PLANNING COMMISSION MEETING  
JANUARY 28, 2025

# Elm Park Planned Unit Development (PUD) & Replat(SUB)

**PC 24 27 PUD 01**

**PC 24 28 SUB 01**

# 6. Riparian Buffer

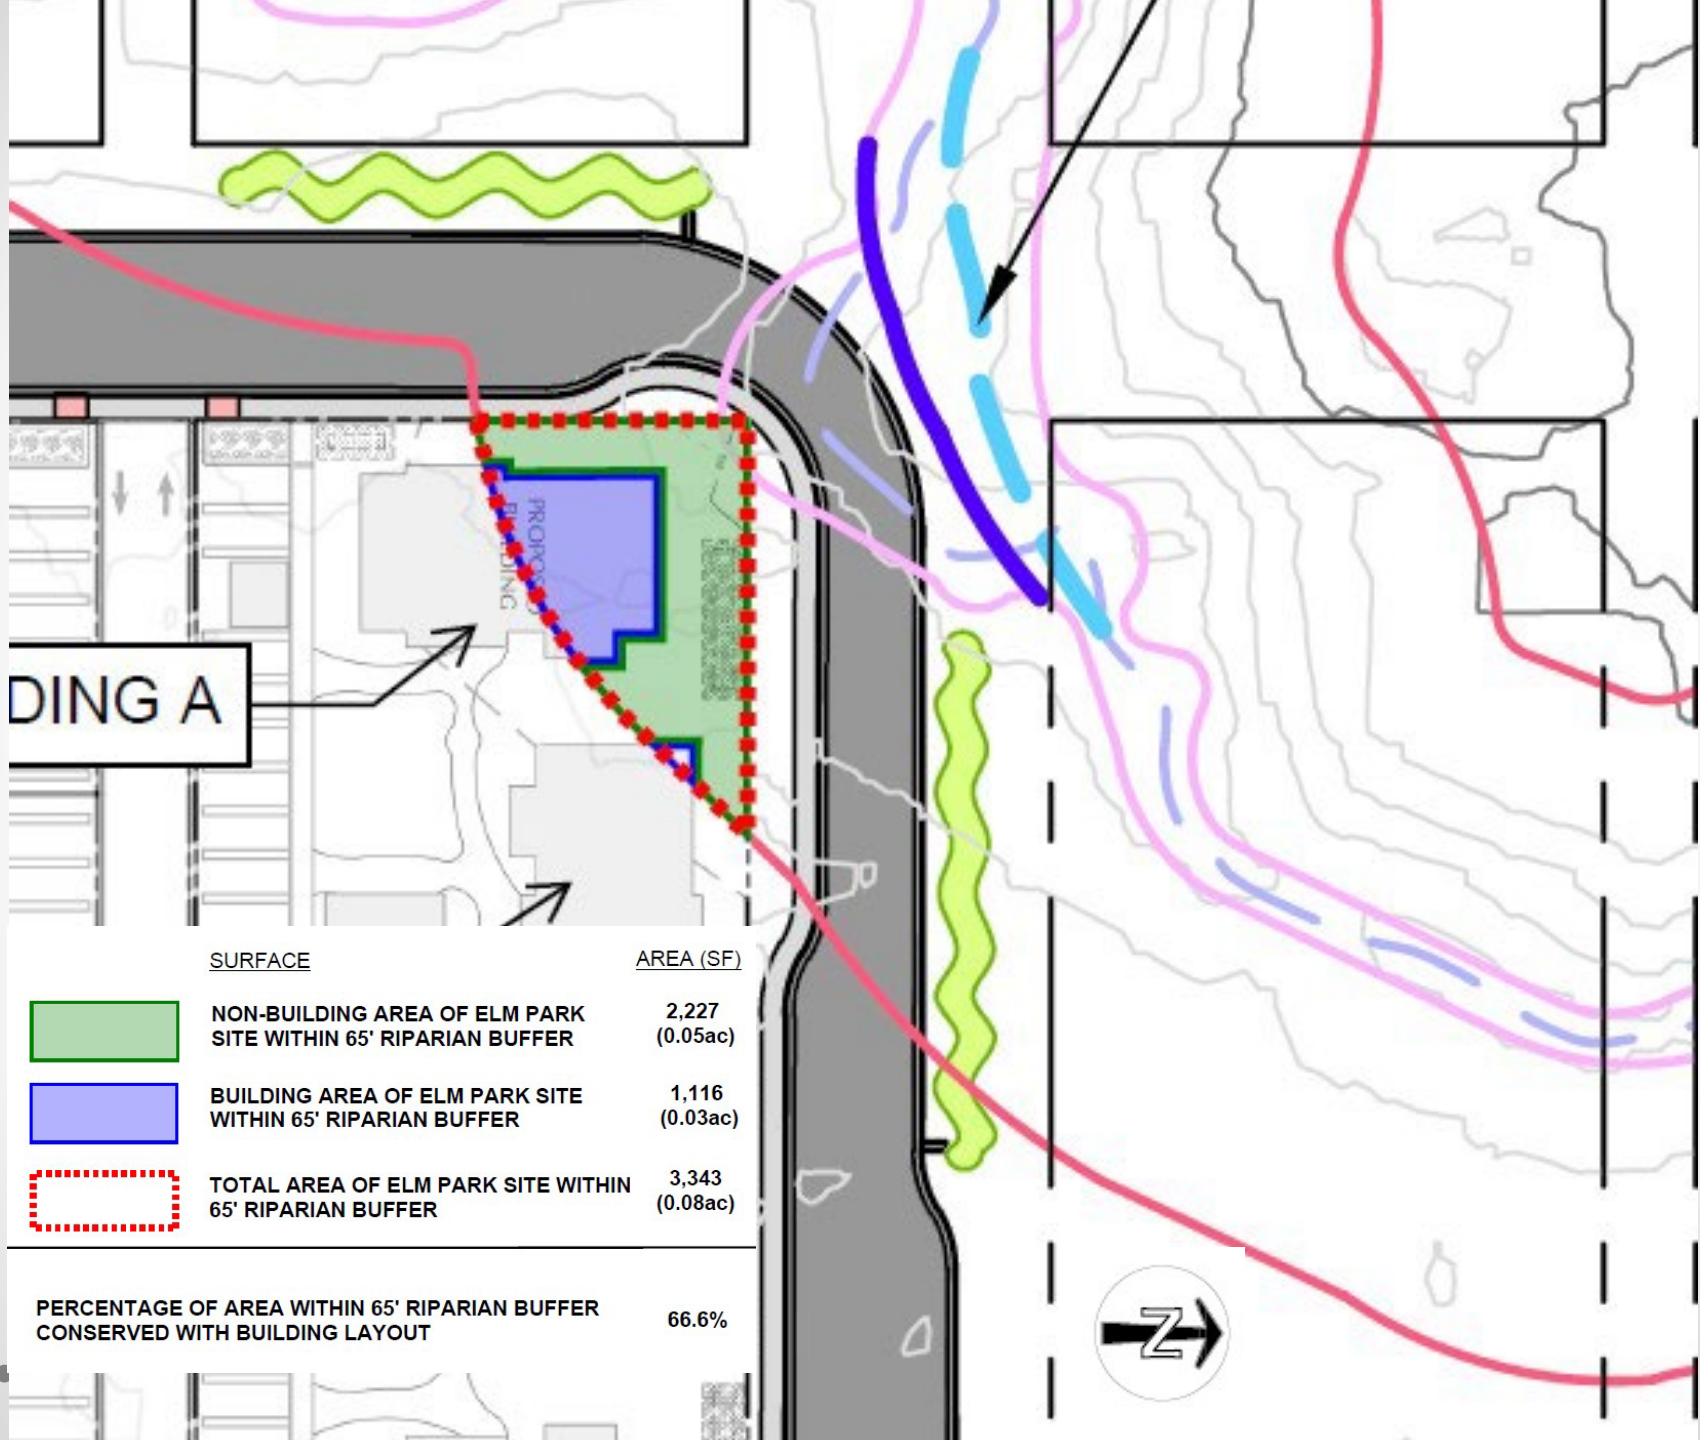
The applicant wants permission to build closer to the protected stream area. They say the city's planned infrastructure improvements will protect the area from harm.

SURFACE	AREA (SF)
 NON-BUILDING AREA OF ELM PARK SITE WITHIN 65' RIPARIAN BUFFER	2,227 (0.05ac)
 BUILDING AREA OF ELM PARK SITE WITHIN 65' RIPARIAN BUFFER	1,116 (0.03ac)
 TOTAL AREA OF ELM PARK SITE WITHIN 65' RIPARIAN BUFFER	3,343 (0.08ac)

PERCENTAGE OF AREA WITHIN 65' RIPARIAN BUFFER CONSERVED WITH BUILDING LAYOUT 66.6%

- Staff recommend approval of Condition #6, but the commission must decide if the intent of the code has been satisfied by the street's application mitigation efforts, and if a buffer area meant for preservation next to the stream is still applicable when intersected by infrastructure.

# 6. Riparian Buffer

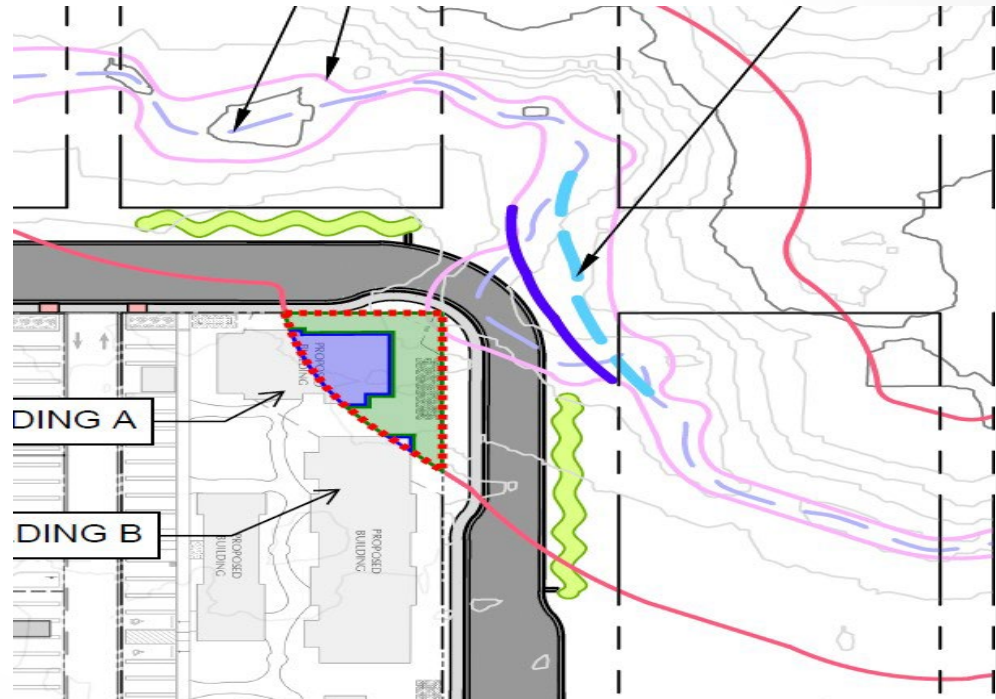
- Do flora and fauna cross the road to access a buffer area that is surrounded by apartments?

# Replat Request

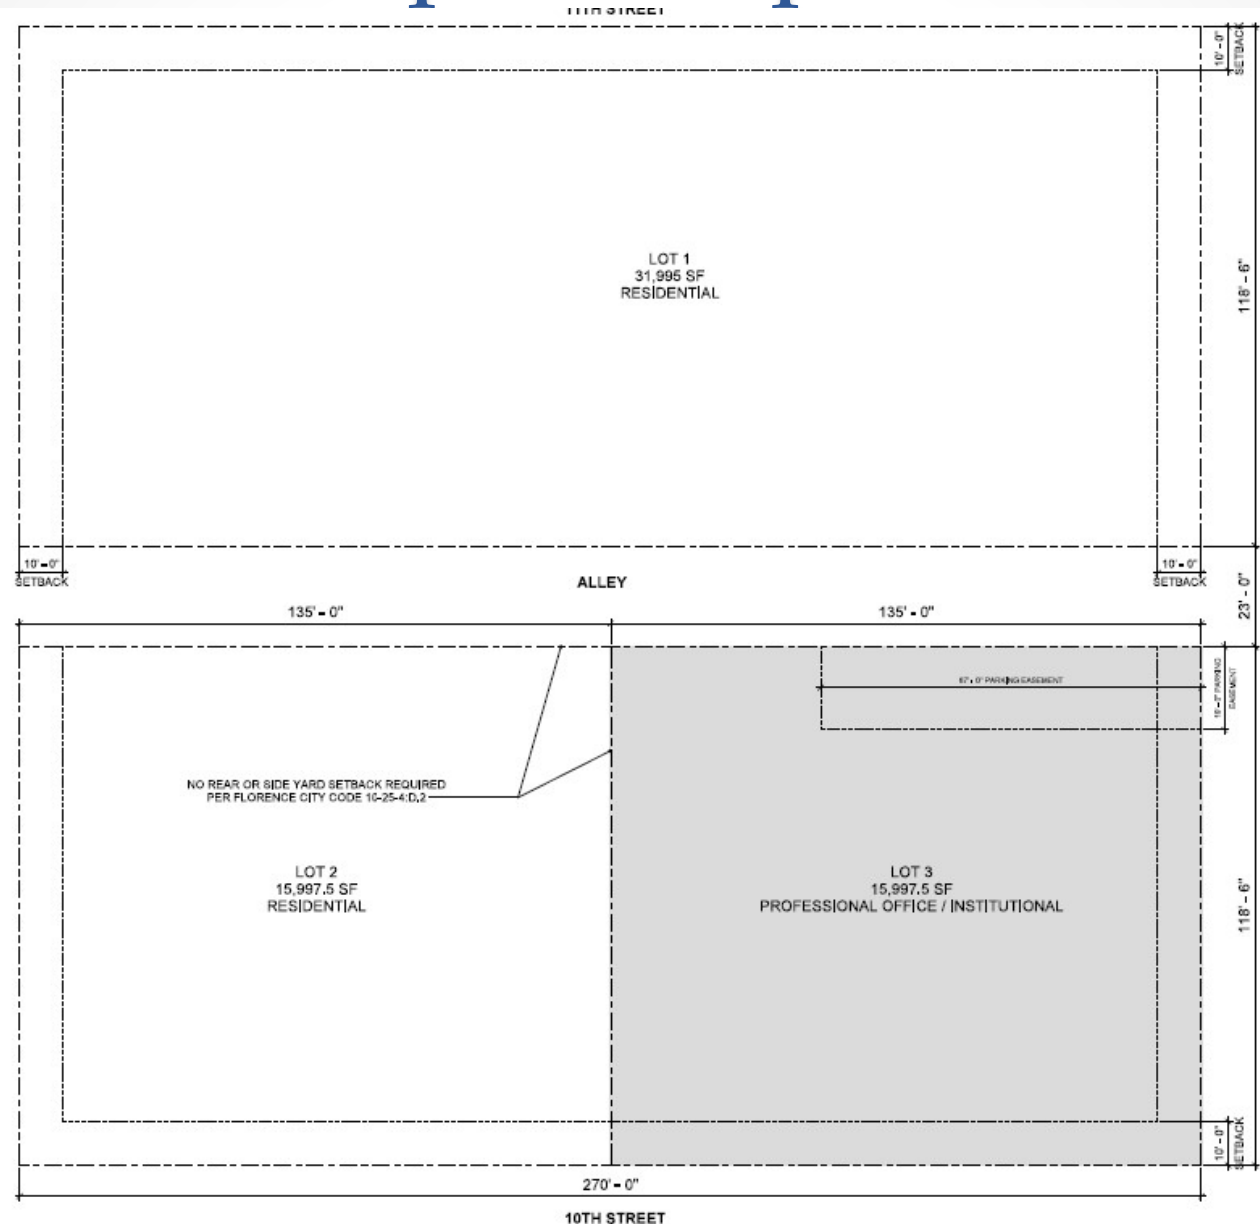
- Director Mike Miller Comments:
- “Due to the type of development that is being proposed, the alley between Fir and Greenwood will be functioning exclusively to the benefit of the Elm Park PUD and the Early Learning Center. The City does not have the resources to provide for the on-going maintenance responsibilities of the alley. Therefore, since there really is no public benefit as proposed (basically the alley is providing access to private parking) Public Works is recommending that the alley be vacated. “
- Staff recommend adding a Condition of Approval requiring the replat to vacate the alley between fir and greenwood.

# Applicant's updates since 12-17

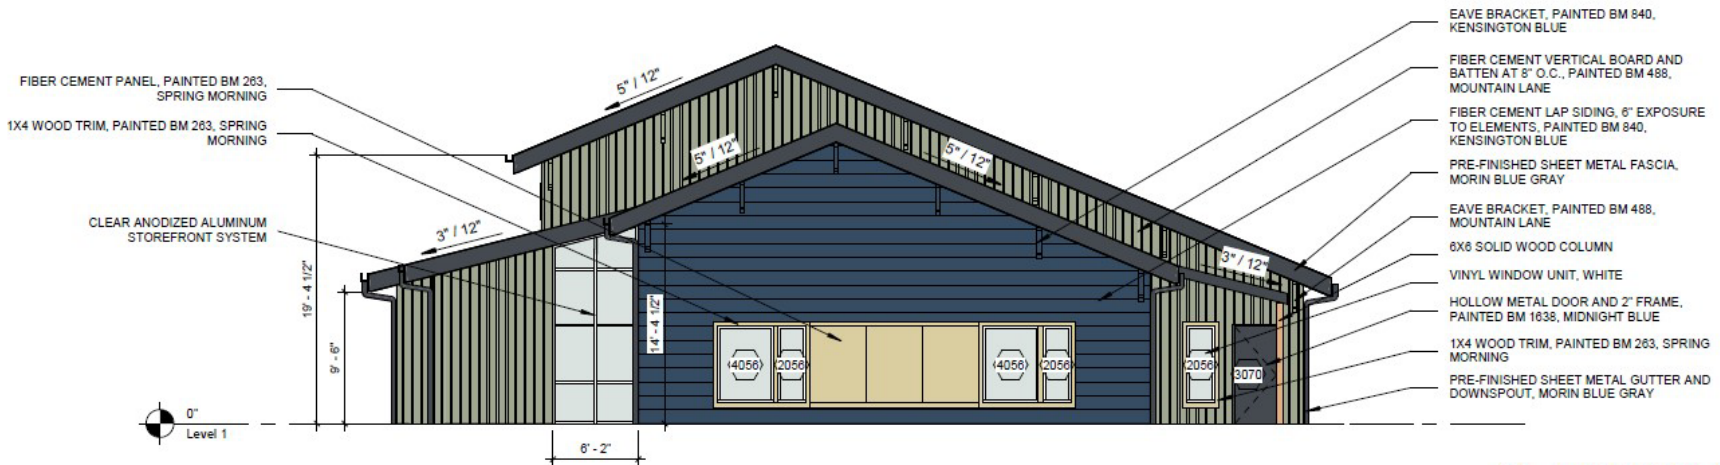
7. A crosswalk has been added across the one-way lane between the sidewalks on the east boundary of Lot 2 and the ELF.

④ BUILDING A - NORTH ELEVATION (FROM 11TH STREET)  
1/8" = 1'-0"

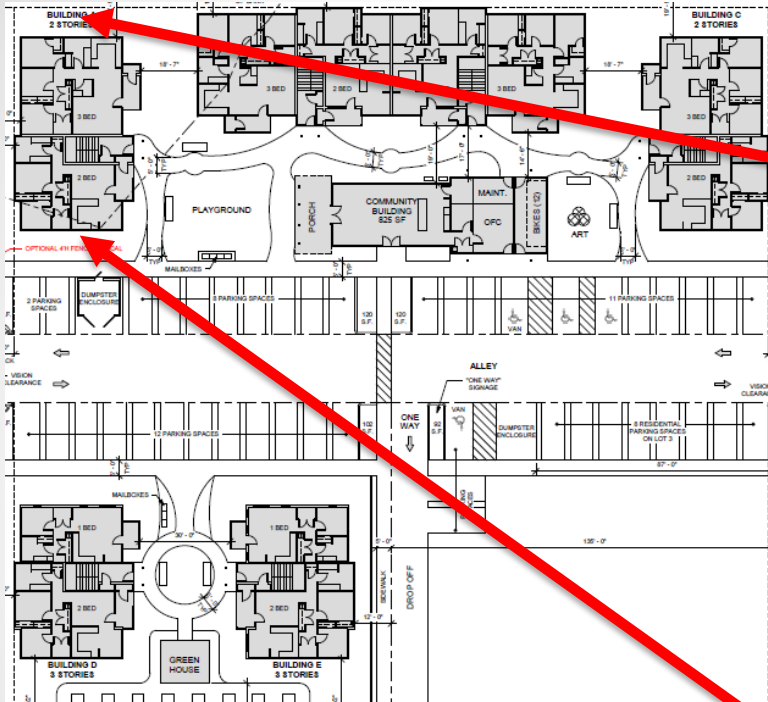
2. Additional architectural enhancements on the north elevations of Buildings A and C
